Safety Recall

N232414720 Steering Gear Shaft Fracture

Revision: 01

Revision Description: This bulletin is being revised to add the final repair for vehicles that did NOT pass the inspection and to include a copy of the customer notification letter. Please discard all previous copies of bulletin N232414720.

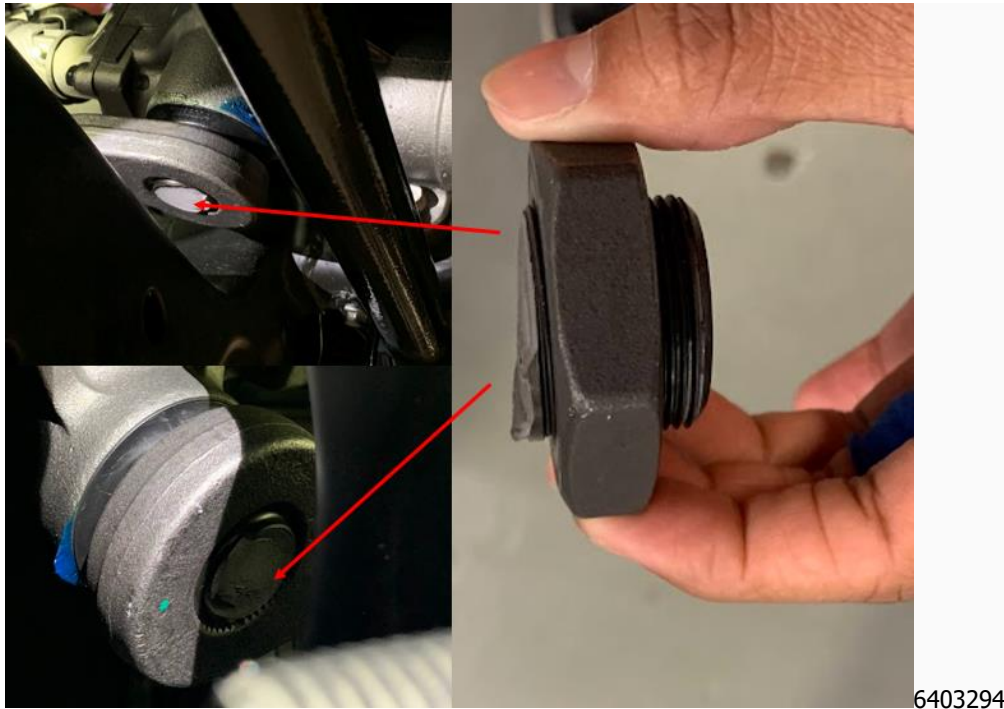
1. Lift the vehicle. Refer to *Lifting and Jacking the Vehicle* in SI.
2. Inspect the Steering Gear Pinion Shaft/Pitman arm nut to see if they are intact.

- If the steering gear pinion shaft is broken/sheared off, as shown above, proceed to step 3.
3. Replace the steering gear. Refer to *Hydraulic Recirculating Ball Steering Gear Replacement* in SI according to the RPOs associated with your vehicle.

- If the inspection determines that the steering gear does NOT need to be replaced (steering gear pinion shaft and nut are intact), no further action is required.
